## DESCRIPTIVE REPORT

*Registry No.* ..... H-11273

*Sublocality* ..... Approaches to Port Clarence

## Revisions Compiled During Office Processing

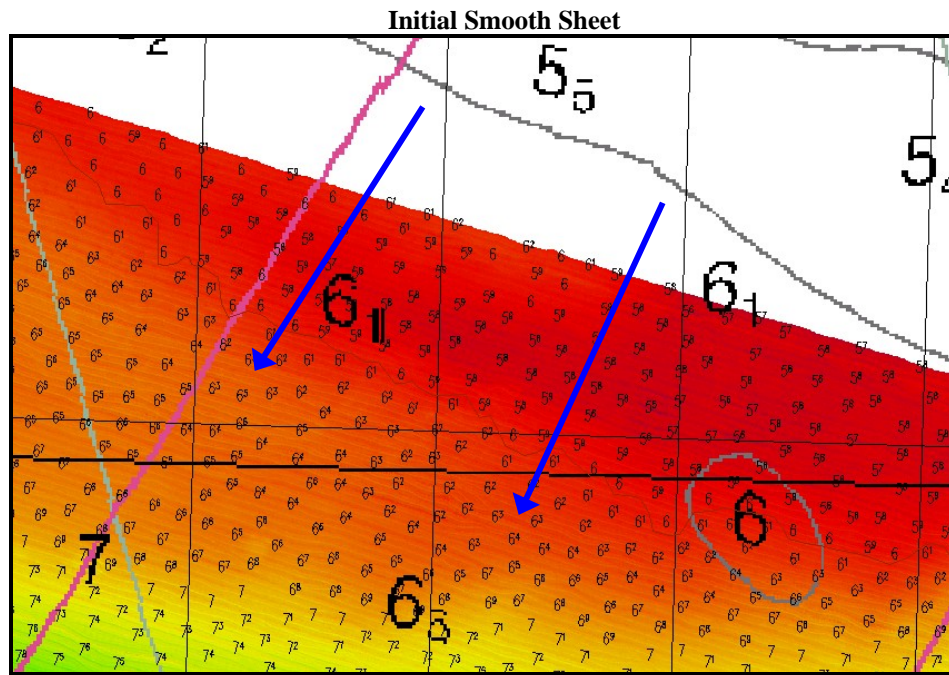
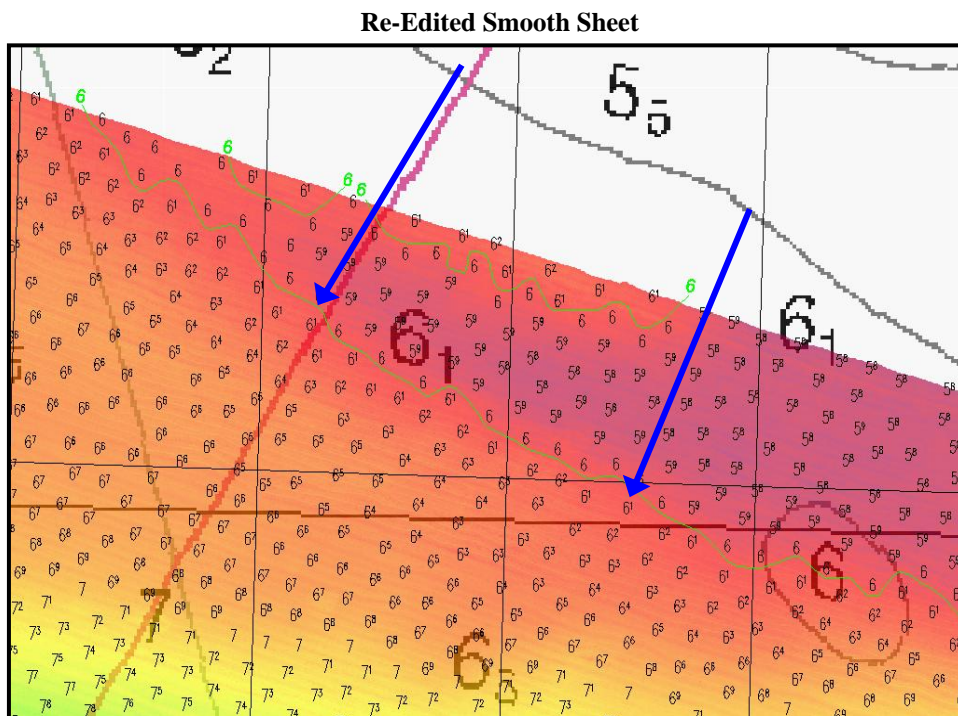
In the vicinity of Latitude N 65° 20' 07" and Longitude W 166° 55' 18" initial smooth sheet soundings show the 6 fathom contour has migrated southwestward by as much as 850 meters.<sup>44</sup> After re-editing, this trend continues. The hydrographer recommends updating the next chart edition by using contours from the re-edited 2005 survey.<sup>45</sup>

<sup>44</sup> Concur with clarification. Survey data indicated that some areas of the 6 fm curve in this vicinity have moved southwestward from the charted curve, but survey data also support charted areas deeper than 6 fathoms that fall north of the H11273 surveyed curve. Chart as shown on the smooth sheet and H-drawing.

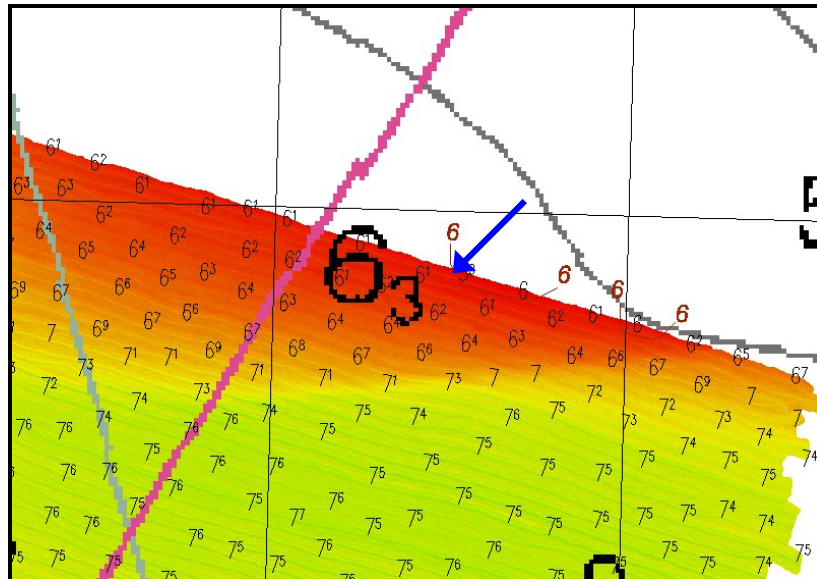
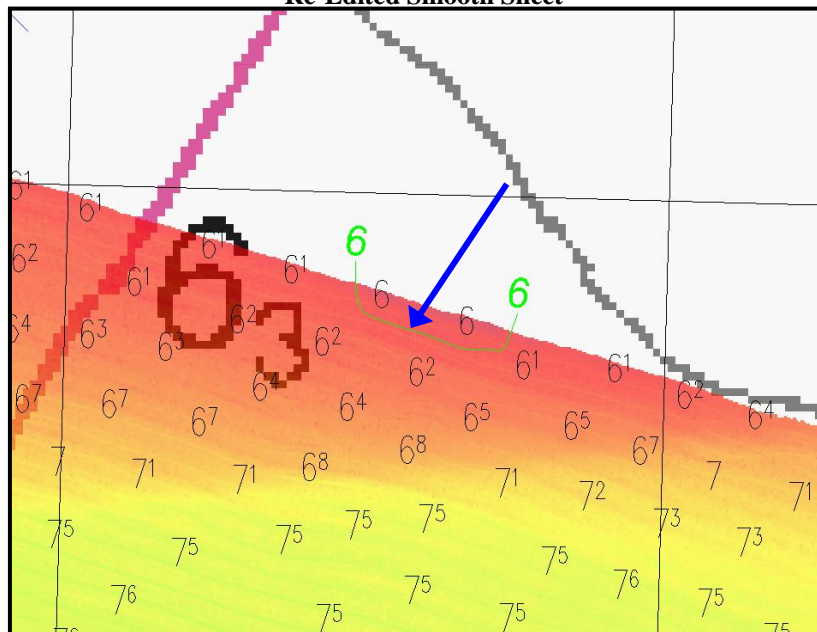
In the vicinity of Latitude N 65° 18' 55" and Longitude W 166° 43' 27" initial smooth sheet soundings show the 6 fathom contour has migrated southward by as much as 250 meters.<sup>46</sup> After re-editing, this trend continues. The hydrographer recommends updating the next chart edition by using contours from the re-edited 2005 survey.<sup>47</sup>

<sup>46</sup> Concur. Chart as shown on the smooth sheet and H-drawing.

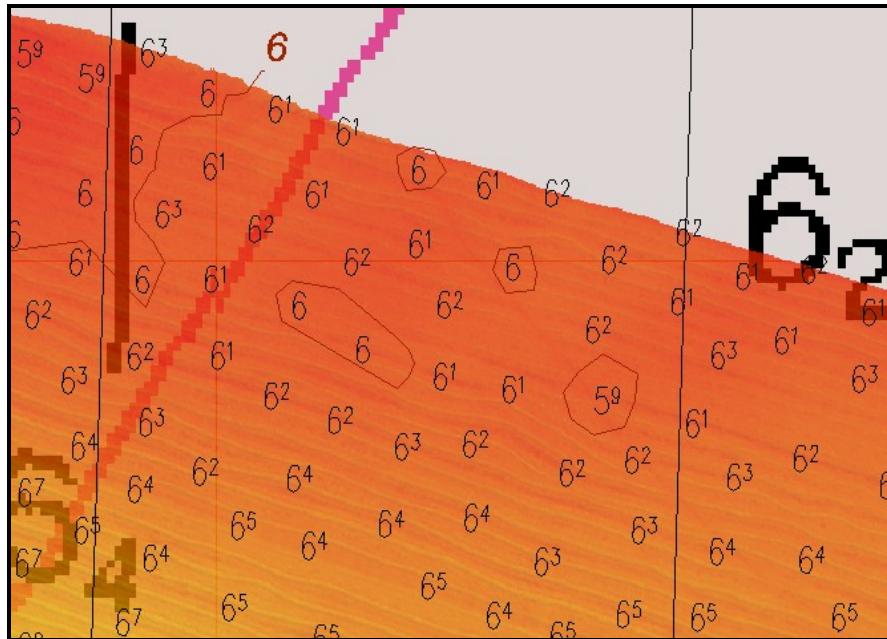
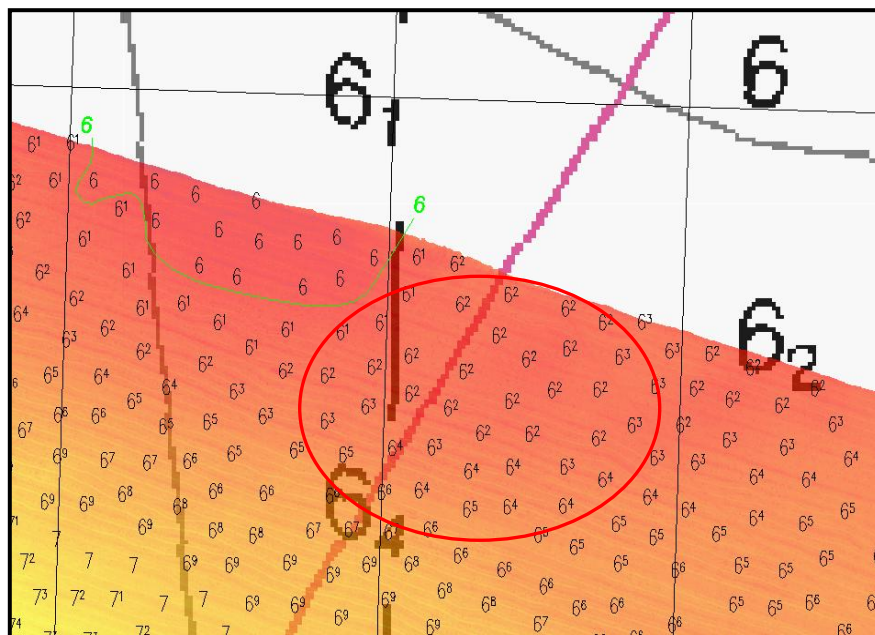
In the vicinity of Latitude N 65° 20' 38" and Longitude W 166° 59' 24", initial smooth sheet soundings show six fathom contours not previously charted. After re-editing, these contours no longer exist. The hydrographer does not recommend adding six fathom contours in this area.<sup>48</sup>

<sup>48</sup> Concur.

Smoothsheet H11273 Overlaid on Chart 16200 13<sup>th</sup> Ed.

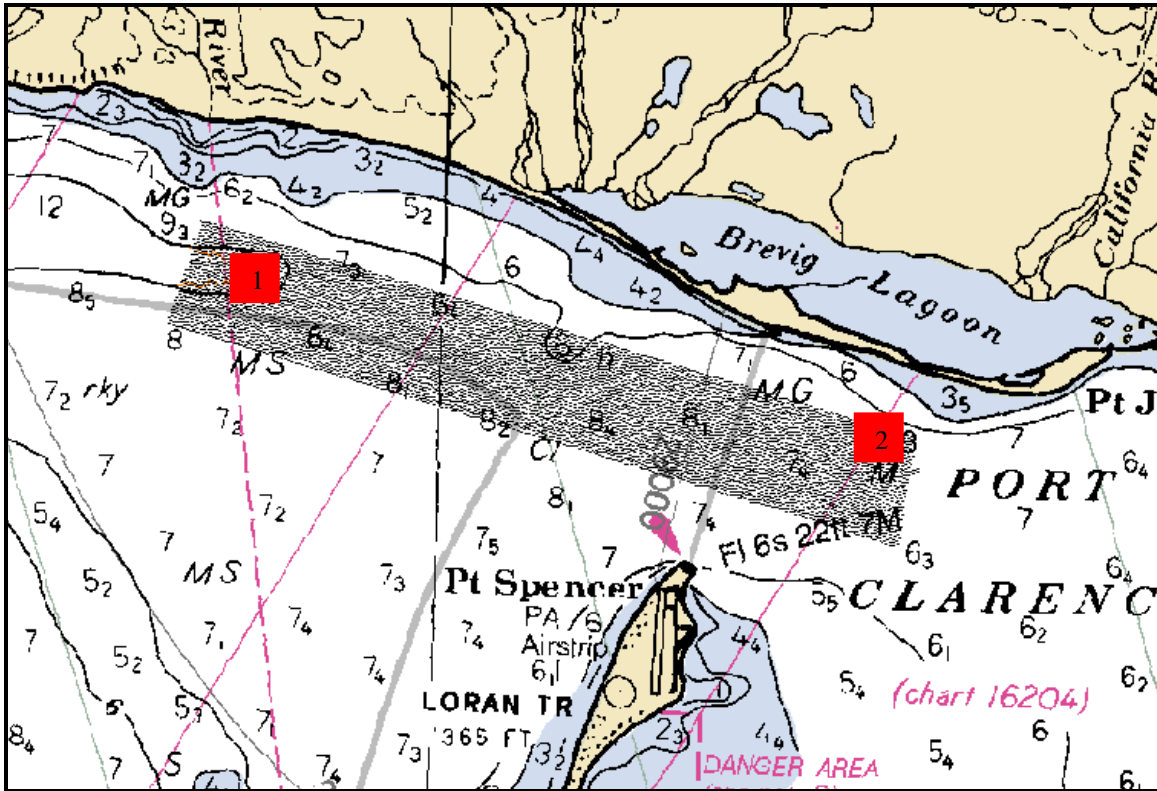
Due to the small scale of this chart, it compares relatively well with the 2005 survey. The vicinity chart above is referenced to two areas in which significant differences were found in the comparison. The re-editing of H-11273 resulted in deeper soundings than those initially reported (described in “Section B2. Quality Control” of this report). Therefore, the differences between charted depths and reported depths have lessened from those originally submitted.<sup>49</sup> The hydrographer recommends updating the next edition of the chart with soundings from the re-edited 2005 survey.<sup>50</sup>

<sup>49</sup> Concur with clarification. Vicinity 1 is a charted sounding of 10 fm 5 ft at Lat 65/21/04 N, Lon 167/07/19 W, where H11273 found a depth of 10 fm 2 ft. Vicinity 2 is a charted sounding of 8 fm at Lat 65/18/43, Lon 166/42/49, where H11273 found a depth of 7 fm 3 ft. Chart as shown on the smooth sheet.

<sup>50</sup> Concur. Chart all areas as shown on the smooth sheet and H-drawing.
